1988 - 1989 Corvette: Recall: Evaporative Emission Hoses

Subject: CAMPAIGN: EVAPORATIVE EMISSION HOSES

Model and Year: 1988-89 CHEVROLET CORVETTE

Bulletin Number: 89C25 - (08/23/1993)

FIGURE 1

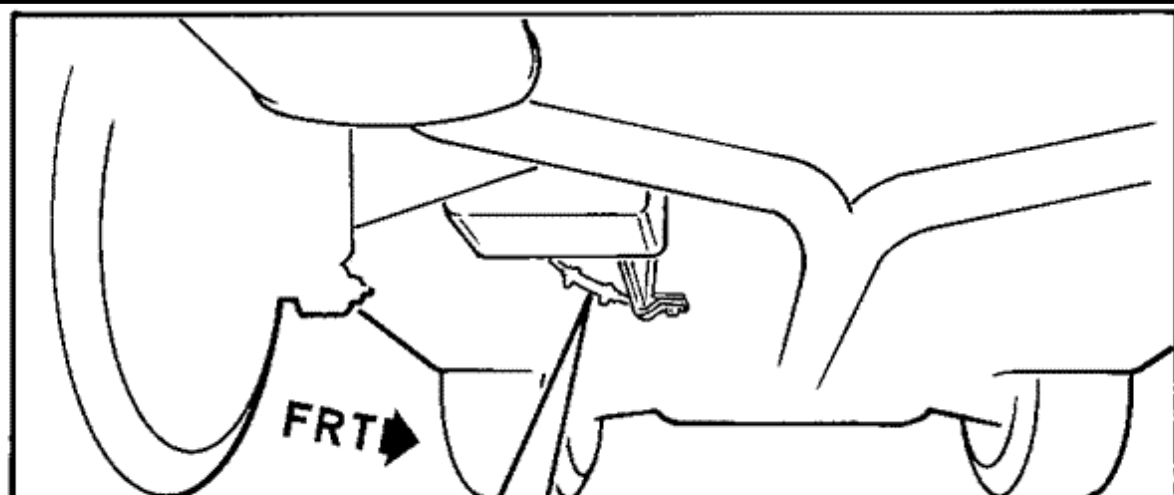
General Motors has determined that certain 1988-89 Chevrolet Corvette model vehicles may experience a condition in which two (2) suspect evaporative emission hoses may deteriorate, crack and leak.

2. Referring to Figure 1, locate rubber hose (approximately 2-9/16" long - 65mm) connecting fuel tank evaporative emission pipe to chassis fore-aft evaporative emission pipe.

3. Remove both hose clamps and hose. Hose clamps and hose will not be reused.
4. Inspect pipes and bend if required to insure ends of pipes are in line with one another.

5. Install two (2) new clamps (P/N 01622744) and new hose (P/N 09442928) onto pipe ends. Insuring hose is positioned an equal distance over both ends. Position clamps onto hose and secure.

FIGURE 2

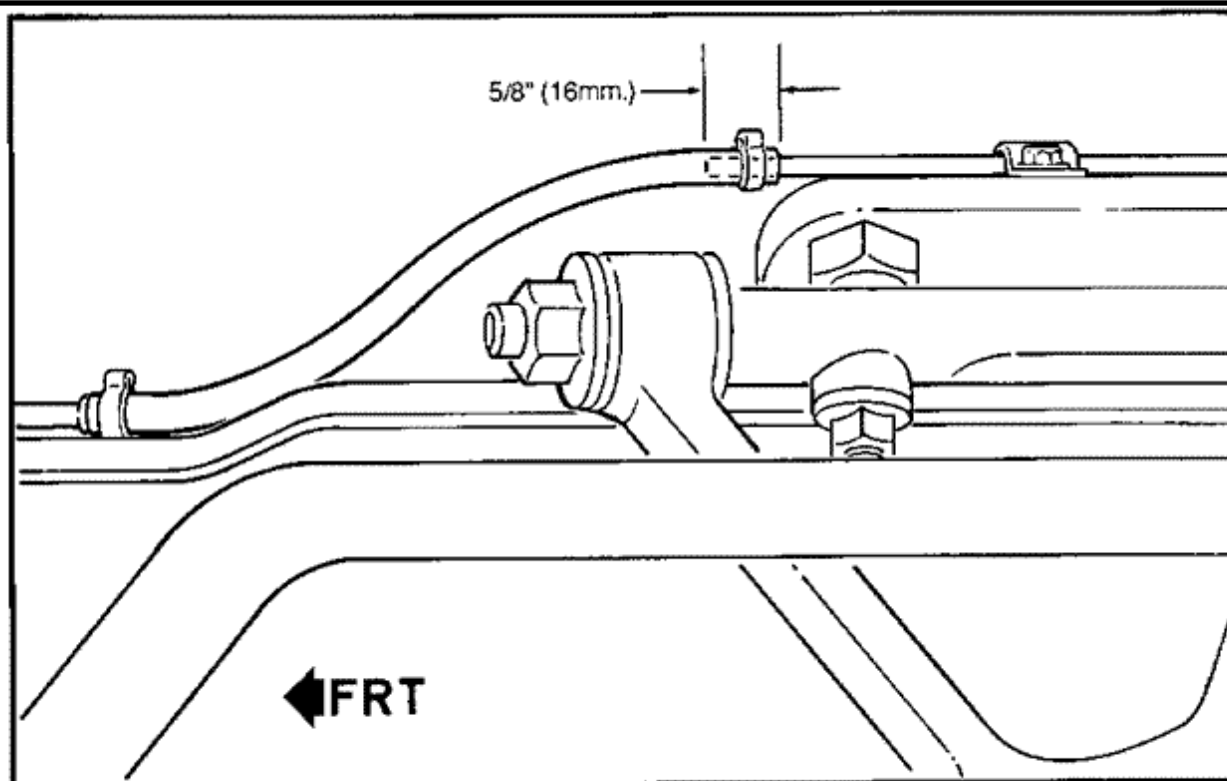
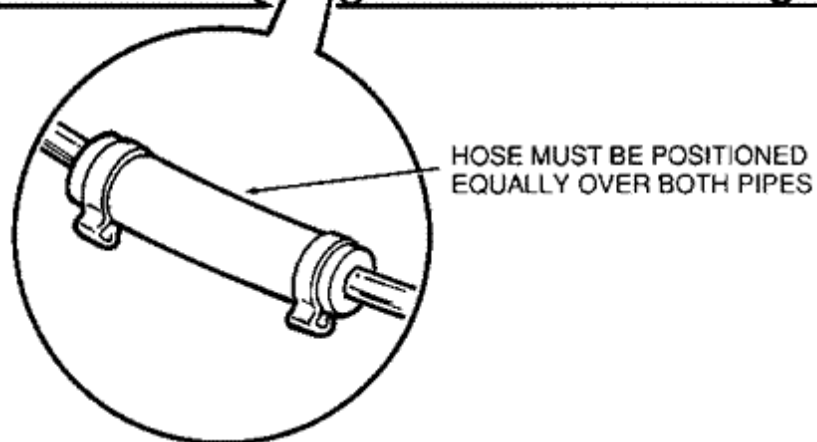
6. Lower vehicle.
7. Underhood, locate the evaporative emission hose connecting chassis fore/aft evaporative emission pipe to evaporative emission line shown in Figure 2.

8. Remove both hose clamps and hose. Hose clamps and hose will not be reused.
9. Install new large clamp (P/N 10028454) over nylon evaporative emission line, and install new small clamp (P/N 01622744) over chassis pipe.

10. Install larger end of new hose (P/N 10248651) over nylon evaporative emission line and install the opposite end approximately 1/2" over the fore/aft chassis pipe as illustrated in Figure 2.

Notice: If hose appears taut when assembled as indicated above, repositioning of chassis fore/aft pipe may be required to alleviate condition.

11. Position clamps onto hose and secure.
12. Install Campaign Identification Label.
